## ANCHOR PRINTING WAREHOUSE JSP22-02

## PLANNING REVIEW

March 15, 2022

Revised Preliminary Site Plan Review

ENLARGED FLOOR PLAN AND ELEVATION

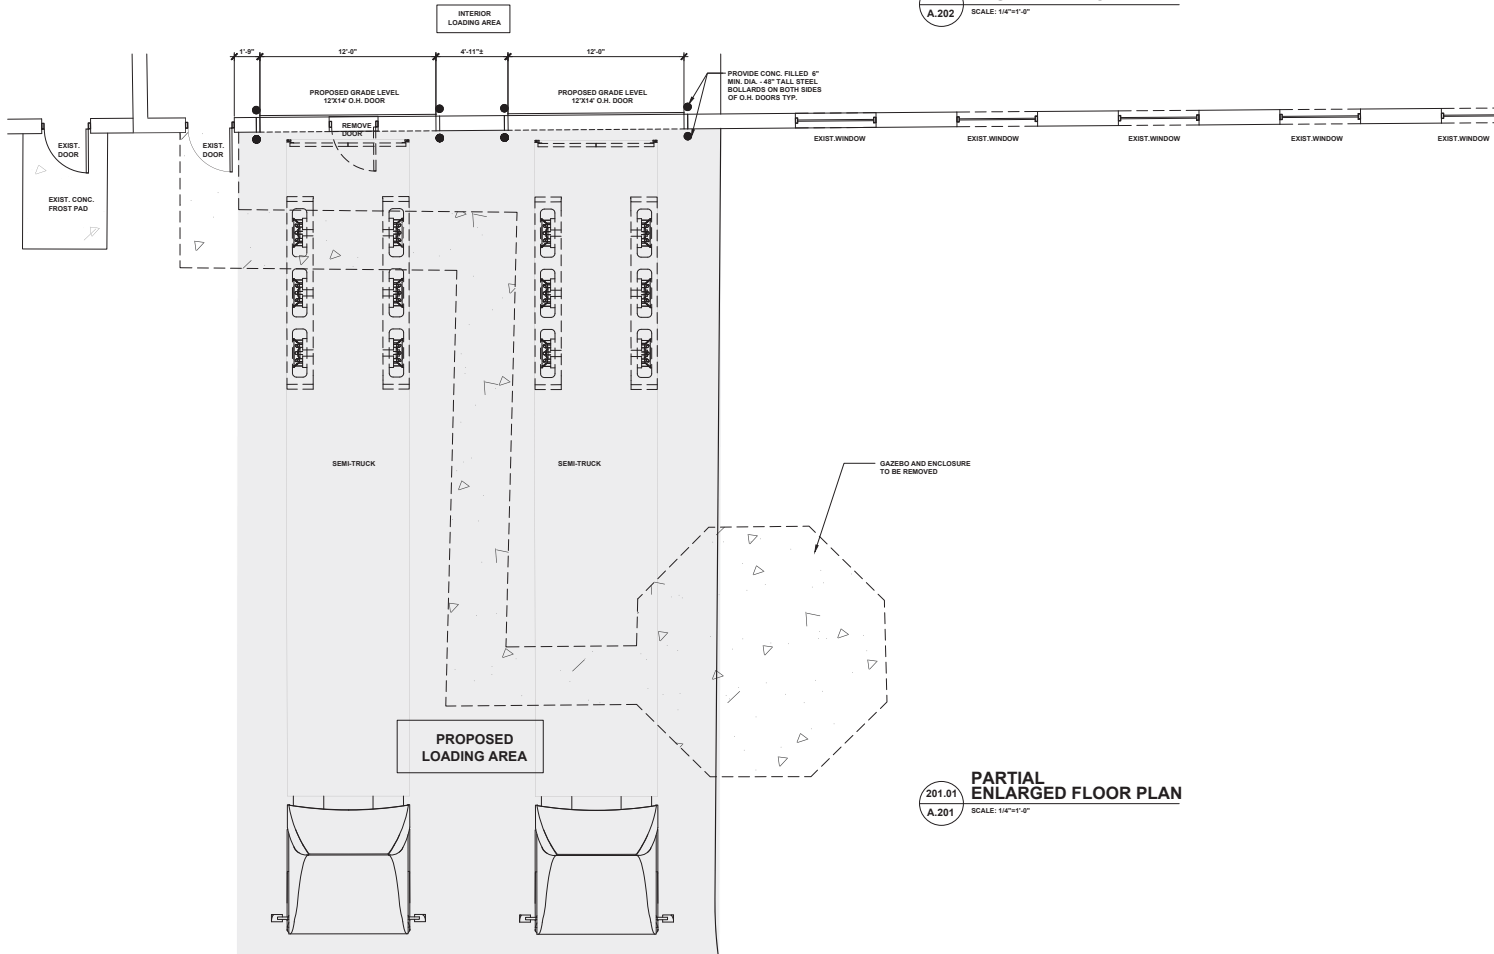
2. Loading Dock Near Residential (Sec. 3.14.5.A): No loading dock or door shall be permitted on or in the wall of a building which faces an abutting residential district. Currently, two overhead doors and a loading dock are proposed on or in the wall of a building that faces an abutting residential district. **The applicant has indicated that they will seek a Zoning Board of Appeals variance for this requirement.**

The following is the Façade Review for Preliminary Site Plan Approval of the above referenced project. This review is based on the drawings prepared by Biddison Architecture, dated 1/11/22. The project consists of removal of the existing gazebo and canopy and the installation of two overhead doors on the east façade. Other façades are unaltered.
